STAFF RECOMMENDATION
1620 Ordway Place
August 16, 2017

Application: New construction—addition
District: Lockeland Springs-East End Neighborhood Conservation Zoning Overlay
Council District: 06
Map and Parcel Number: 08310013400
Applicant: Cheyenne Smith
Project Lead: Melissa Baldock, melissa.baldock@nashville.gov

Description of Project: Application is to construct a rear addition that is taller than the historic house. **Recommendation Summary:** Staff recommends approval of the addition with the following conditions: **1.** Staff approve the final details, dimensions and materials of windows and doors prior to purchase and installation; **2.** Staff approve the roof color, dimensions and texture; and **3.** The HVAC be located behind the house or on either side, beyond the mid-point of the house. With these conditions, staff finds that the addition meets Section II.B. and III.B. of the Lockeland Springs-East End Neighborhood Conservation Zoning Overlay design guidelines.	**Attachments** **A:** Site Plan **B:** Elevations

01 SITE PLAN Scale: 1/16"=1'-0"

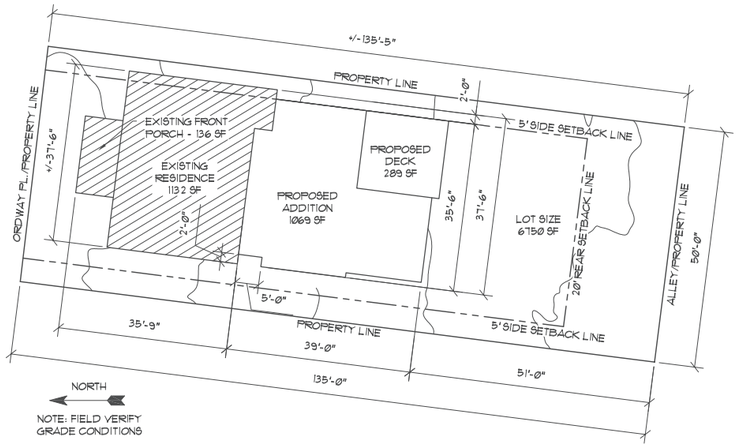
Setback: The proposed addition meets all base zoning setbacks. It will be five feet (5') form the left side property line and nine feet, six inches (9'6") from the right side property line. It will be over fifty-one feet (51') from the rear property line. Staff finds that the proposed addition meets Sections II.B.3. and II.B.10. of the design guidelines.

Appurtenances & Utilities: No changes to the site's appurtenances were indicated on the drawings. The location of the HVAC and other utilities was also not noted. Staff asks that the HVAC be located on the rear façade, or on a side façade beyond the midpoint of the house.

1. Staff approve the final details, dimensions and materials of windows and doors prior to purchase and installation;
2. Staff approve the roof color, dimensions and texture; and
3. The HVAC be located behind the house or on either side, beyond the mid-point of the house.

01 RIGHT ELEVATION (WEST)

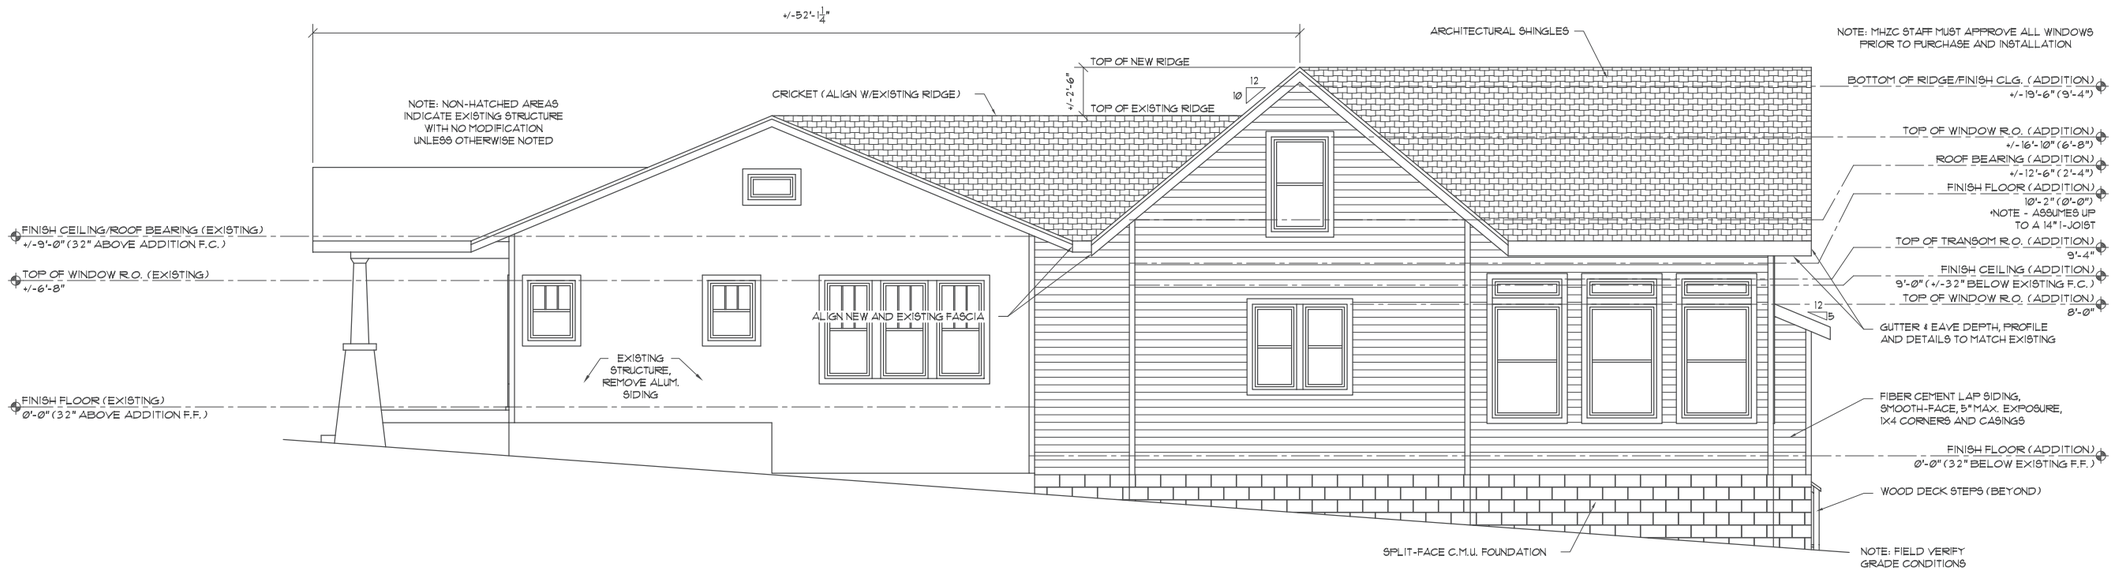
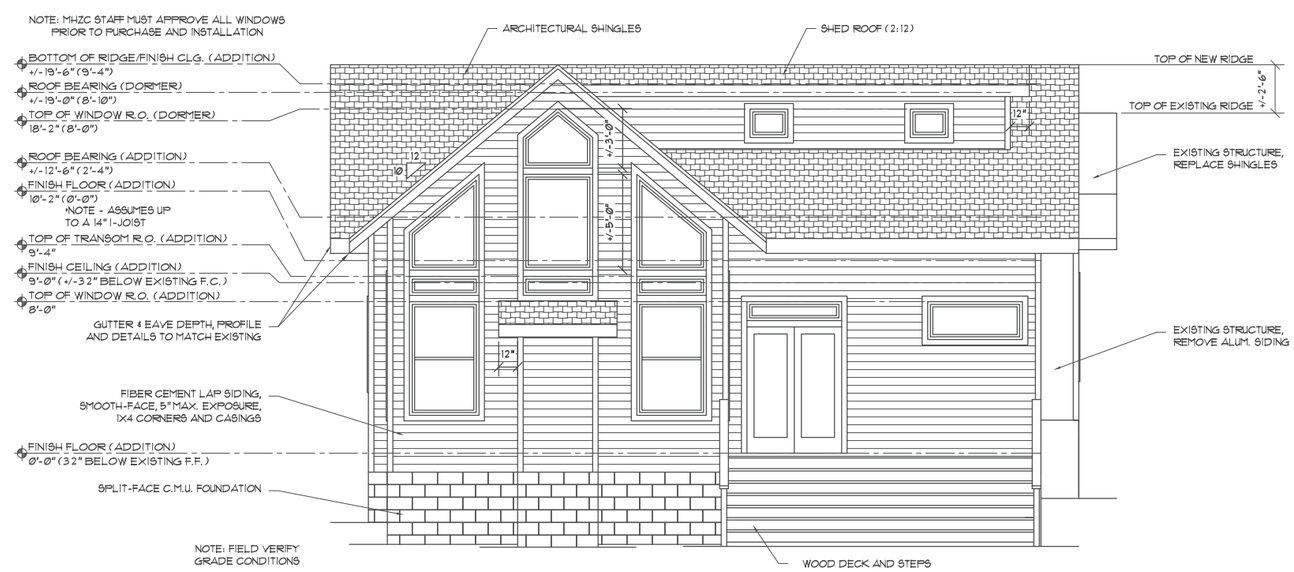
The addition connects to the back of the historic house at a point approximately six inches (6”) below the ridge of the historic house. At a point approximately fifty-feet (50’) back from the front of the house, the addition increases in height to be two feet, six inches (2’6”) taller than the historic house. The design guidelines allow for additions to be taller in some instances, only when necessary and when the roof form minimizes the additional height. The roof form of the addition is a side gable, like the existing building, which will minimize its visibility. Staff finds that the proposed extra height is appropriate, as the historic house is a true one-story house with a modest footprint, a slightly taller addition is a way to get additional space in an upper level while keeping the footprint appropriate and the proposed roof form minimizes the additional height. The applicant has made use of the drop in grade to sink the floor line of the addition lower than that of the historic house, keeping the additional height to just two feet, six inches (2’6”).

Roof form: The proposed addition will have gabled roof forms. The addition ties into the historic house with a 10/12 gable. The taller portion of the house will have a 10/12

side gable, which is appropriate. The rear living room portion of the addition will also have a 10/12 gable. The side gable portion of the addition will have shed dormer with a slope of 2/12. The dormer is inset one foot (1') from the side wall of the addition, and is therefore inset three feet (3') from the line of the wall of the historic house, which staff finds to be appropriate. Staff finds that the project's roof forms meet Sections II.B.5. and II.B.10. of the design guidelines

02 LEFT ELEVATION (EAST)

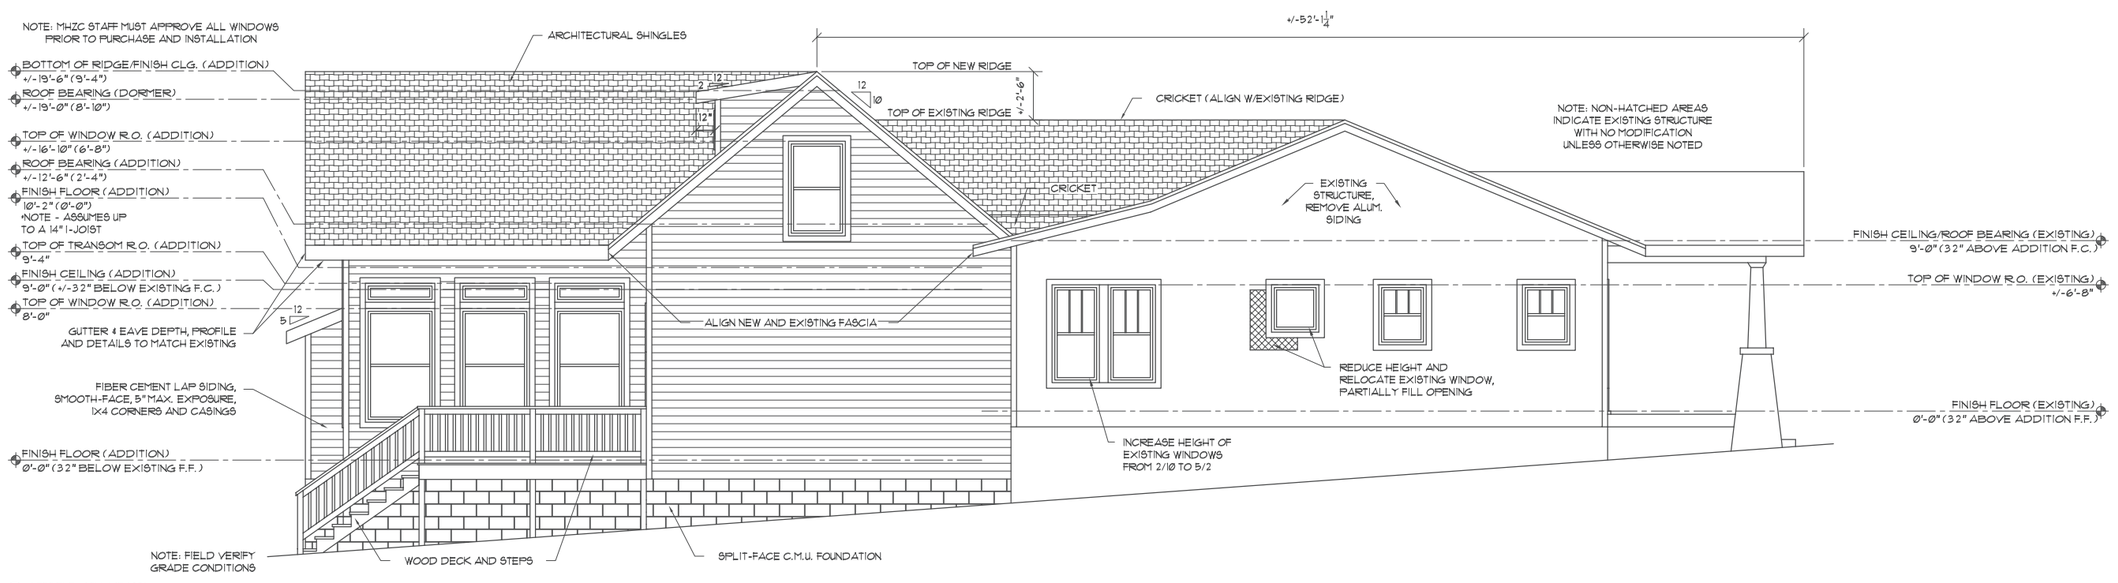
Partial Demolition: The applicant intends to remove the non-historic metal siding, which staff finds to be appropriate. The siding underneath will be restored, if possible. The applicant intends to alter the window openings on the left façade (Figure 3). The double window at the back of the left façade (marked in red on Figure 3) will be enlarged to match the paired window opening on the front façade. The smaller window towards the

back (marked in blue on Figure 3) will be relocated about nine inches (9”) to the right and shortened by six inches (6”). Staff finds that the alterations to the window openings on the left façade to be appropriate for several reasons. They are located on a secondary façade, in the back half of the façade, where they are less prominent. In addition, the altered window openings will be consistent with the historic house’s window pattern, locations, and sizes. Staff therefore finds that the alterations of the window openings to meet Section III.B.2. for appropriate demolition.

Proportion and Rhythm of Openings**:** The changes to the window openings on the historic house's left façade are described under "Partial Demolition." The windows on the proposed addition are all generally twice as tall as they are wide, thereby meeting the historic proportions of openings. There is an expanse of nineteen feet (19') of wall space on the left side without a door or window opening. Staff finds this expanse to be appropriate because it is inset two feet (2') from the side of the historic house and it is located about forty feet (40') from the front of the house. This wall will not be highly visible from the street and the lack of a window will not detrimentally affect the historic character of the historic house. Staff finds the project's proportion and rhythm of openings to meet Sections II.B.7. and II.B.10. of the design guidelines.
